Product Change Notification

PCN No: 2010-10-08-01
Report Date: October 8, 2010
Subject: GLK24064-25 PCB Rev 4.0 New Board Revision Release

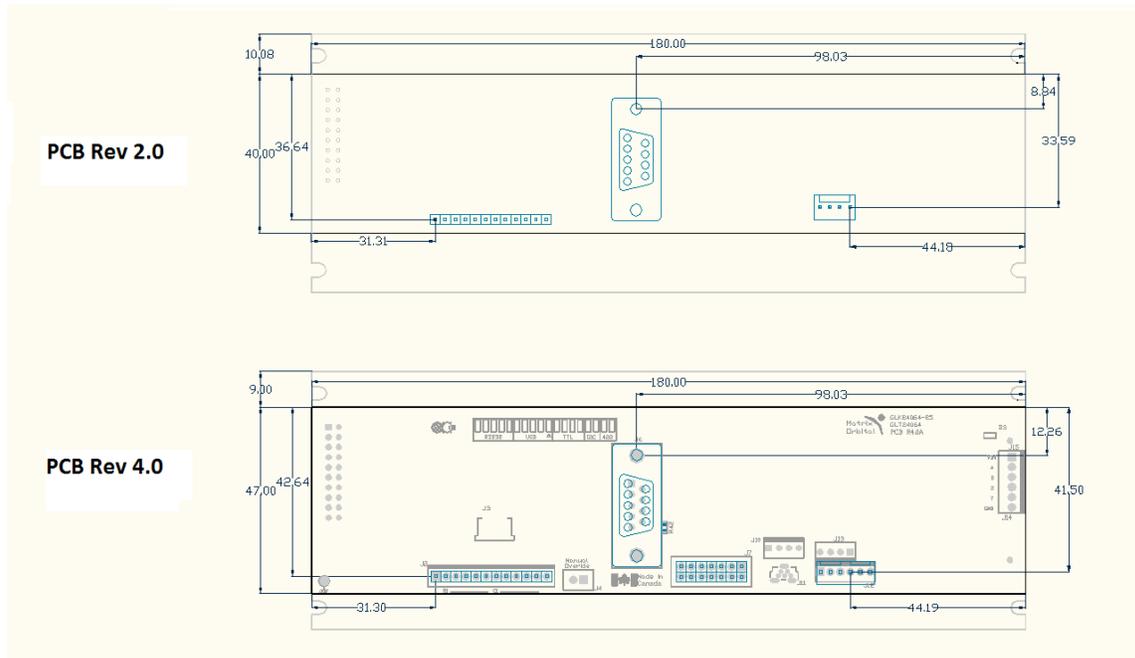
14) There are minor changes on the PCB itself; the new PCB Rev 4.0 is slightly bigger, with minor connector location changes:

PCB Rev 2.0

PCB Rev 4.0
